**3<sup>rd</sup> Further Information**

**Proposed Temporary Warehouse (excluding Dangerous Goods Godown) with Ancillary Facilities  
for a Period of 3 Years and Associated Filling of Land and Pond in "Agriculture" Zone,  
Lot 1291 (Part) in D.D. 107, Fung Kat Heung, Kam Tin, Yuen Long, New Territories**

**(S.16 Planning Application No. A/YL-KTN/1004)**

## Responses-to-Comments

DRAWING NUMBER  
**FIGURE 3B**

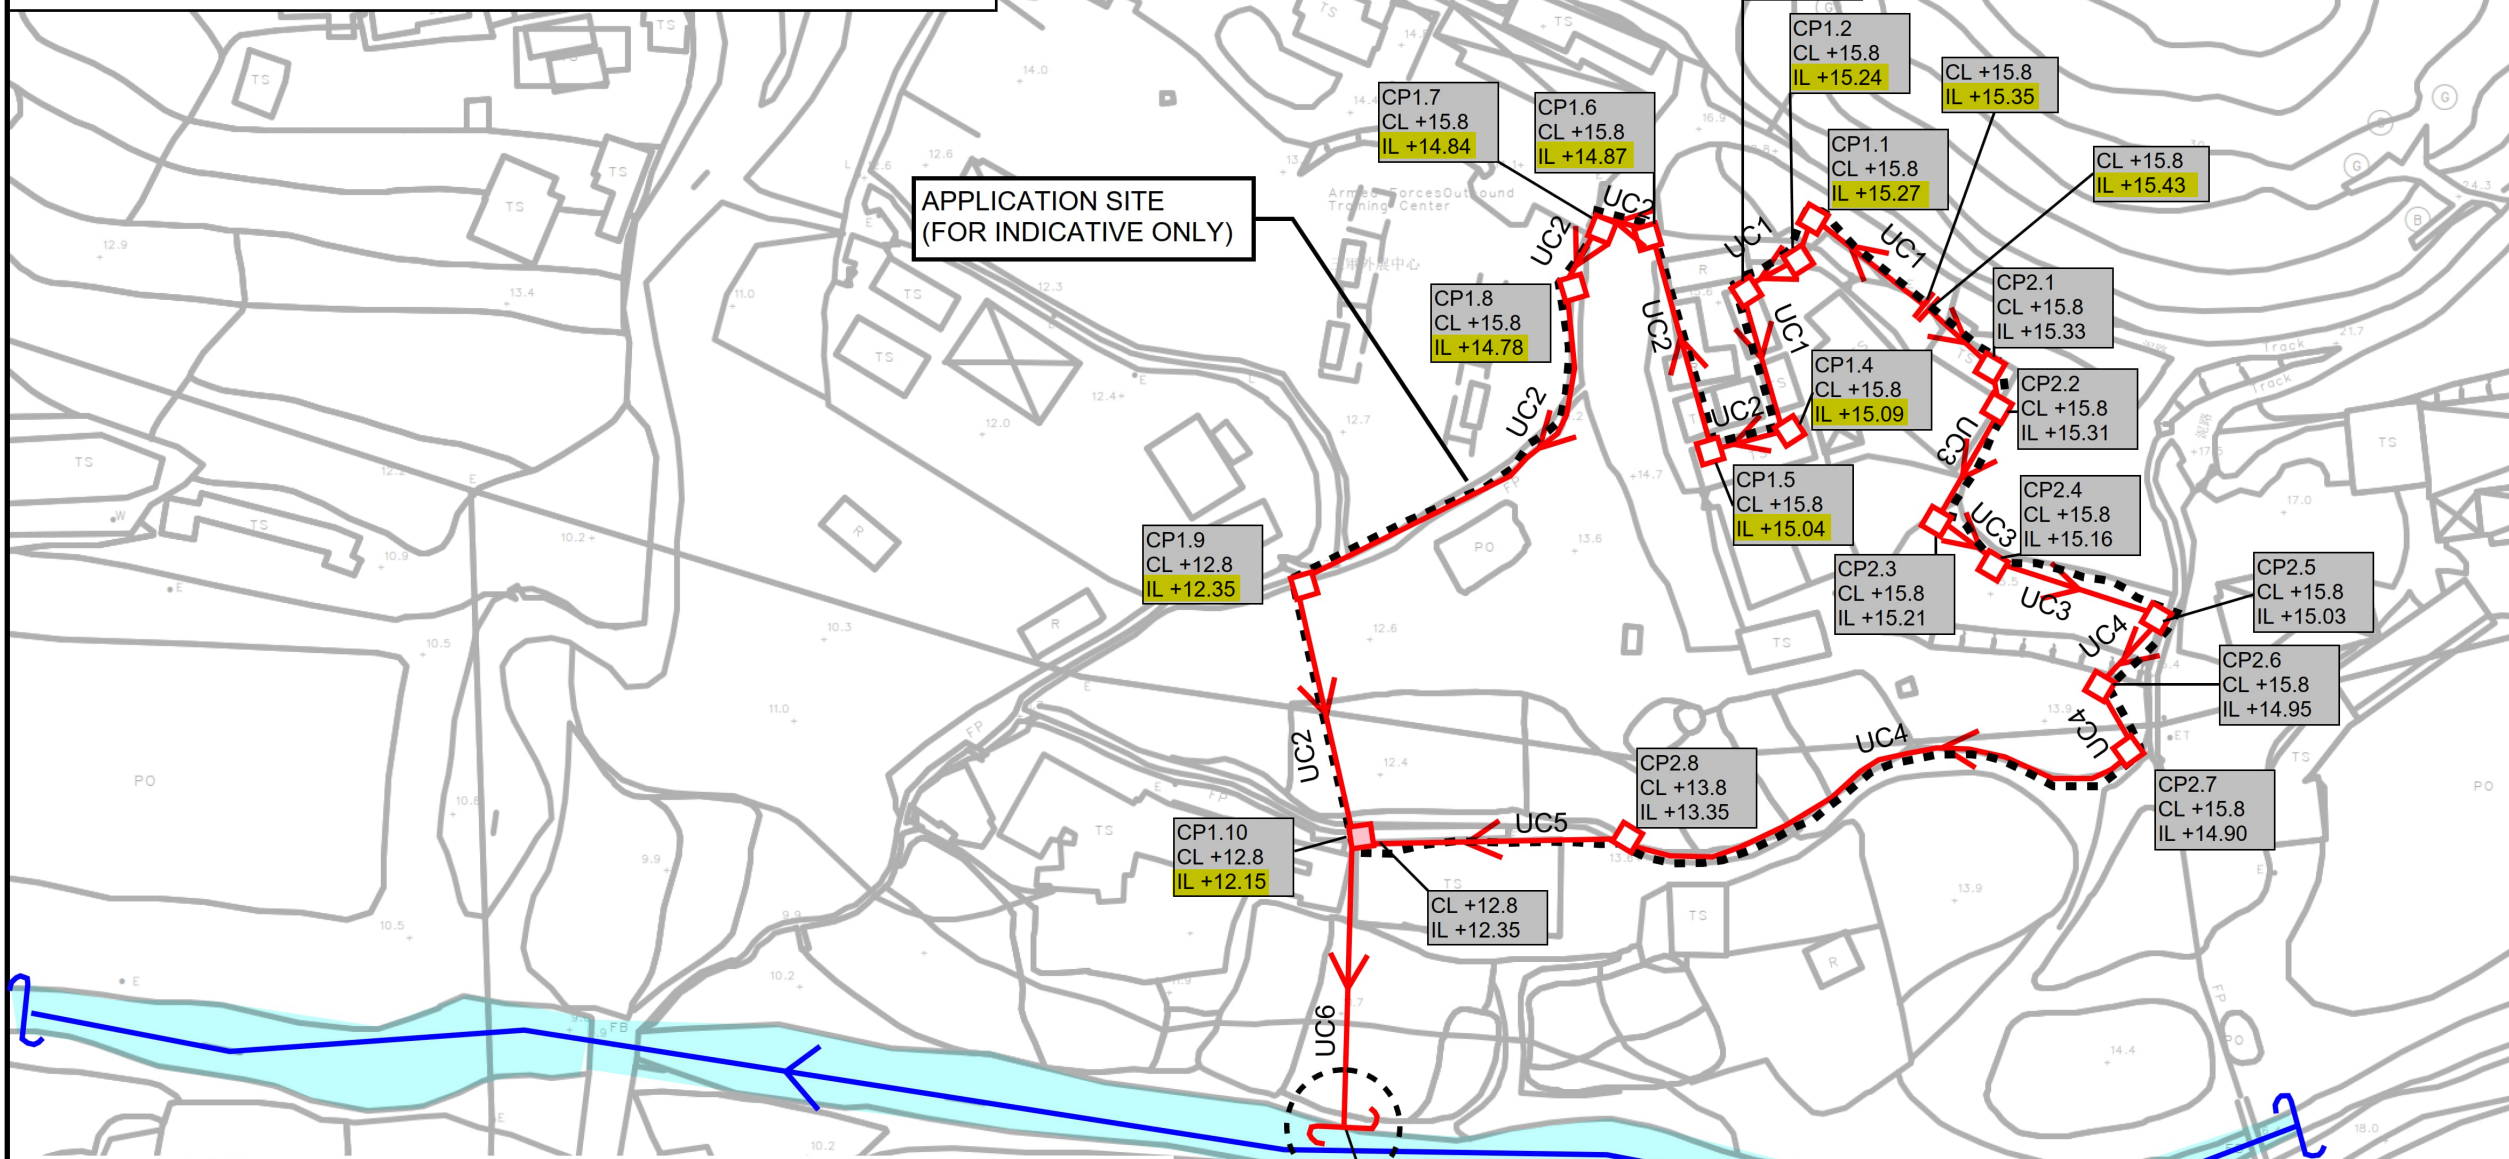
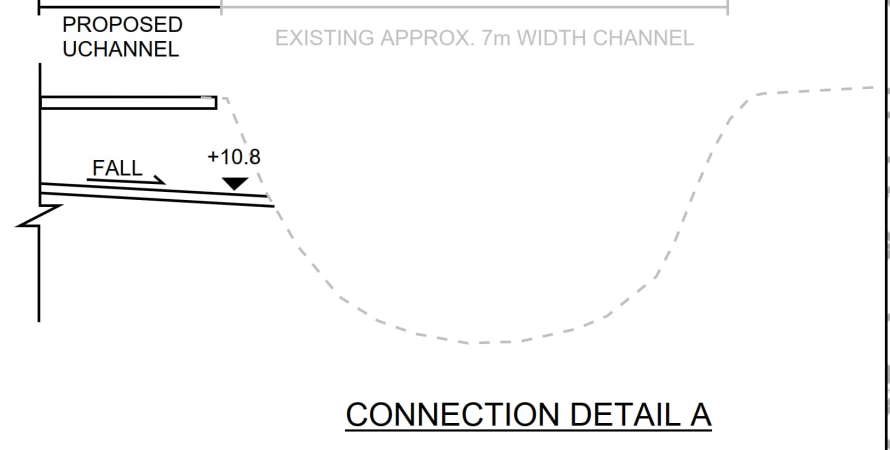
(a)	As the 30% paved area is a rough estimate, so that the u-channel 1 capacity has been checked up to 89.24% which is considered underestimated. Please upgrade the u-channel size as appropriate.	The u-channel 1 size is upgraded from 300mm to 375mm. Please refer to revised <b>Appendix A</b> and <b>Figure 3B</b> .

(b)	Similar to Comment 1, please also upgrade the size of u-channel 6 for conservative approach.	Noted. The u-channel 6 size is upgraded from 600mm to 675mm.  Please refer to revised <b>Appendix A</b> and <b>Figure 3B</b> .

- UCHANNEL TYPE**
- UCHANNEL 1 (UC1) - 375mm, MIN. 1 IN 200
  - UCHANNEL 2 (UC2) - 450mm, MIN. 1 IN 200
  - UCHANNEL 3 (UC3) - 300mm, MIN. 1 IN 200
  - UCHANNEL 4 (UC4) - 450mm, MIN. 1 IN 200
  - UCHANNEL 5 (UC5) - 450mm, MIN. 1 IN 100
  - UCHANNEL 6 (UC6) - 675mm, MIN. 1 IN 200

Appendix D

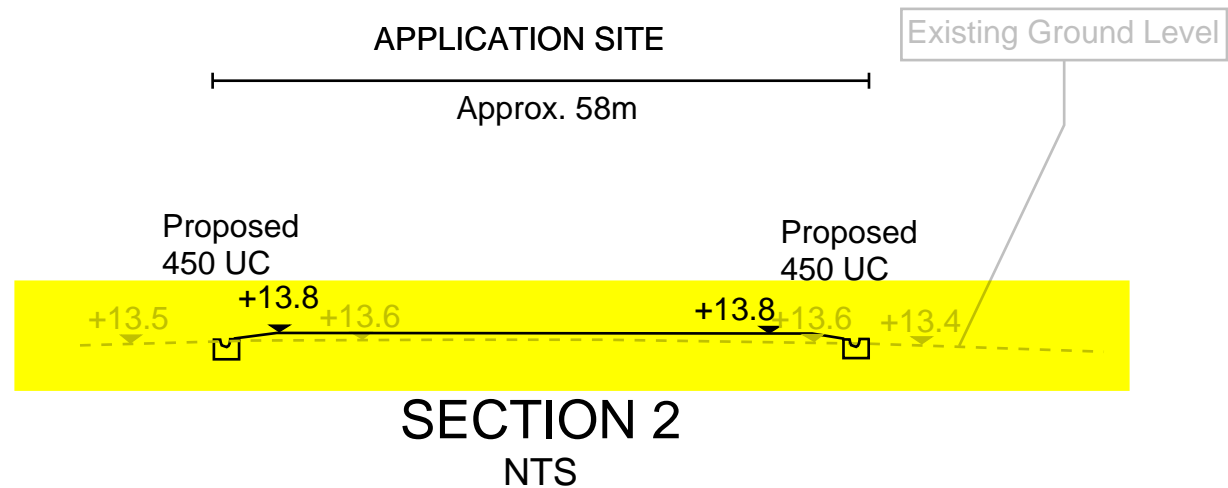
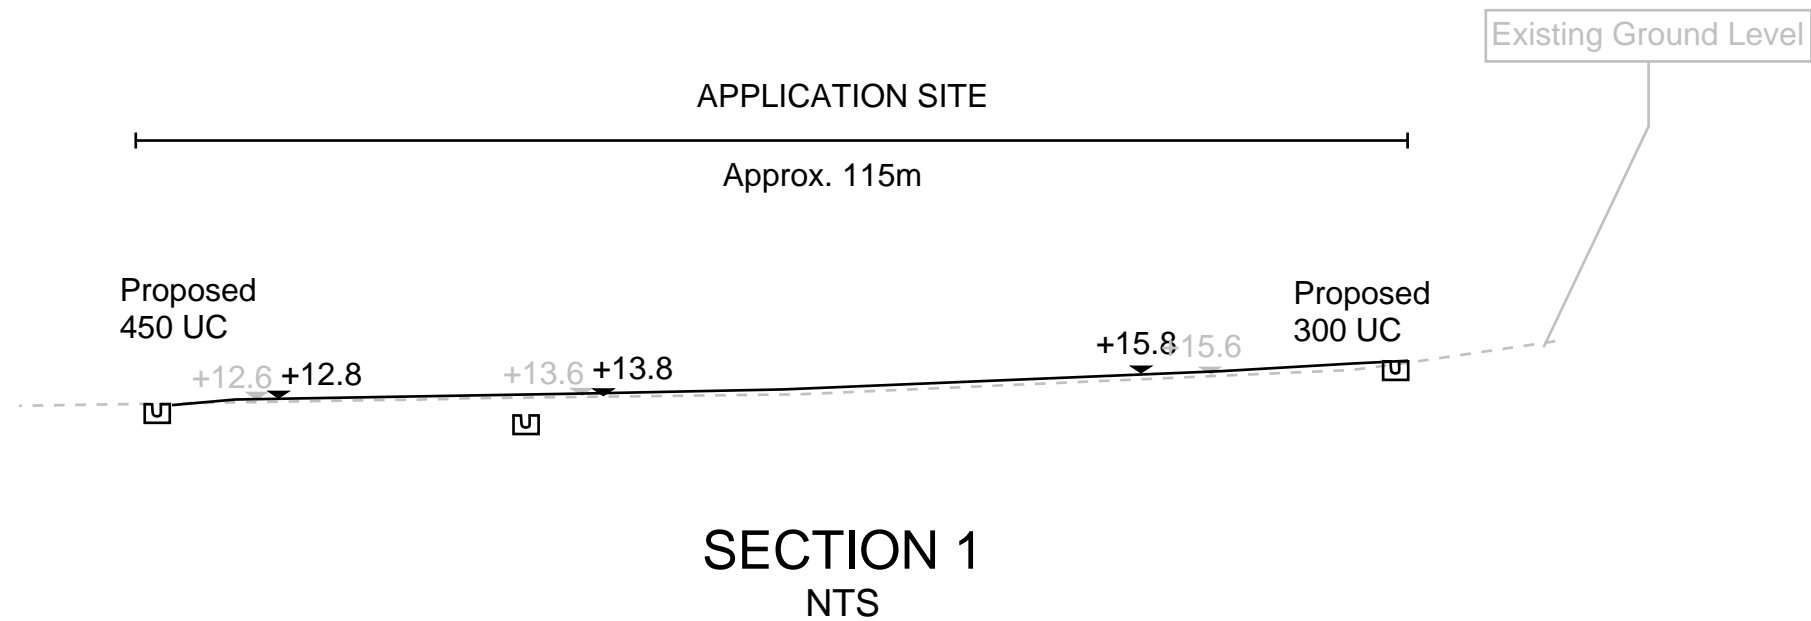
(d)	Cross sections: Adjacent ground levels should be shown on drawings. The extent of north area in Section 2 should also be included.	Noted. Please refer to the revised <b>Appendix D</b> .
